Review of egusphere-2025-379

Extension of AVHRR-based climate data records: Exploring ways to simulate AVHRR radiances from Suomi-NPP VIIRS data

By: Karl-Göran Karlsson, Nina Håkansson, Salomon Eliasson, Erwin Wolters, Ronald Scheirer

Reviewer 1

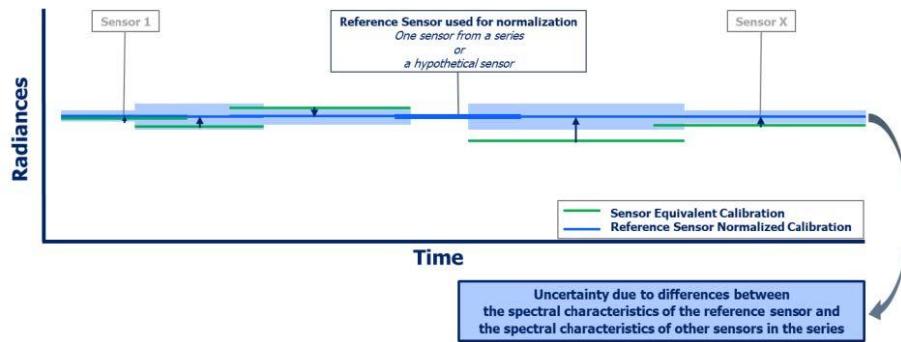
The work presented is related to work done by the Global Space-based Inter-Calibration System (GSICS) international partnership, an initiative launched in 2005 by the World Meteorological Organisation (WMO) and the Coordination Group for Meteorological Satellites (CGMS). Further the work has many elements touched upon in the framework of the FIDUCEO (Fidelity and Uncertainty in Climate Data Records from Earth Observations) Horizon 2020 project funded by the European Union. Within GSICS and FIDUCEO good practices and common terminologies for doing [harmonization](#) and [homogenization](#) - all satellites are forced to look like a "reference sensor", AVHRR on NOAA-19 in this paper - of level-1 observations. Hereto:

- Can the authors explain in their introduction how the presented work relates to what is being done within GSICS and FIDUCEO?
- Can the authors use the terminology suggested in GSICS and FIDUCEO, and avoid confusing terminology in different fora?

For illustrative purposes here a schematic representation of the homogenization principle:

Author response: We certainly should have used the appropriate terminology applied by GSICS and FIDUCEO and we have therefore now corrected this by completely rewriting Section 2.1 and also adjusted some further paragraphs in subsequent sections. We found it best to introduce these definitions here and not in the Introduction part. So, we propose a completely new introduction of Section 2.1 (lines 82-101):

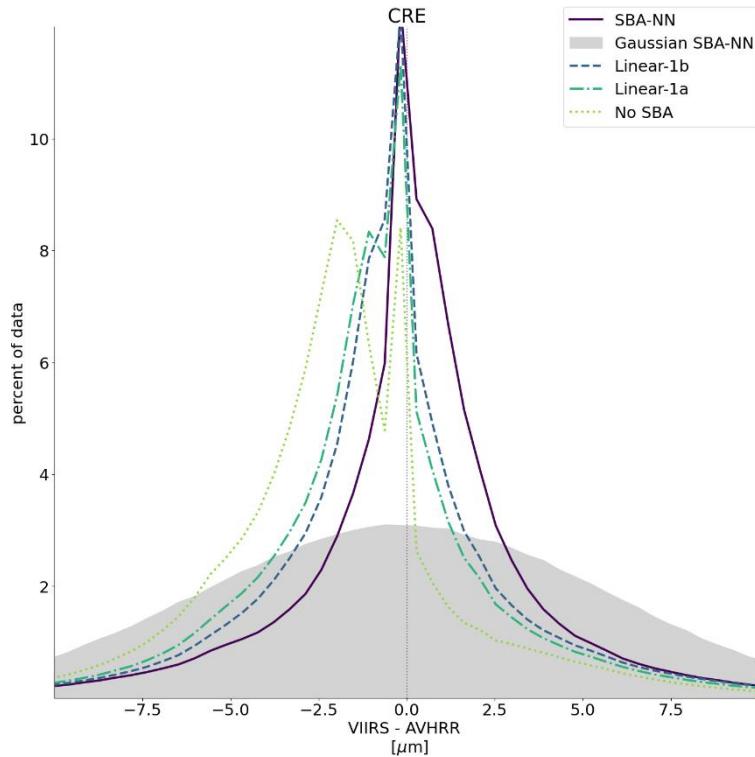
Figure 7, 8, 9

These figures present scatterplots of data pairs of cloud property retrieval from two different satellites. Although the authors did everything to collocate and synchronise the data pairs, much of the observed scatter is simply the result so collocation and synchronisation differences and does not talk so much about the performance of the SBAF correction. To mitigate this, it would be better to present the results as frequency distributions of differences as is done in Figure 6. Can the authors comment why they have chosen to use scatterplot instead of frequency distributions to present the results?

Author response: We decided to exclusively show frequency distributions in the same way as previously done for radiance comparisons in Figure 6. Notice here that we are now applying the new notation “No SBA” to denote the case when uncorrected VIIRS radiances for AVHRR-heritage channels are used in the PPS AVHRR environment”.

We give here an example for cloud effective radius (CRE) parameter:

With reference to the previous discussions and the introduction of the new category “No SBA”, it is clear that to use VIIRS radiances without corrections in the AVHRR processing environment leads to particular problems for the CRE parameter (dotted green line in the figure). This problem seems to be solved after applying the SBA-NN corrections.
